**Secure 1000 Radiation Emission
 Measurement**

FORM R-0646-1
 (Single Pose)

Re: Rapiscan AIT System Radiation Survey Reporting

R-0646-1 Addendum (Documentation Errors)

1. In Beam Dose Measurement: Survey Table. 1

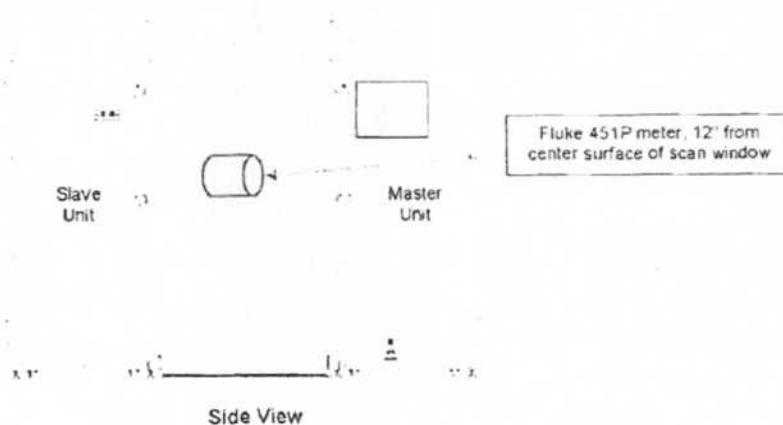
1. No value indicated for background radiation. Typical values range from 7uRem/hr to 13uRem/hr at sea level. Note: Absence of value has no adverse impact on calculations.
2. Technician indicated scan time as 7 seconds. Correct scan time is 3 seconds.
3. TABLE 1: Incorrect presentation of data in Column 3 for Measured Exposure. Indicated values are 16uR and 17uR. Corrected values are 1.6uR and 1.7uR. The values were corrected by technician when calculating Effective Dose.

The service technician should attend refresher training.

The corrected data indicates this system was operating within expected parameters. No re-survey is required for this system.
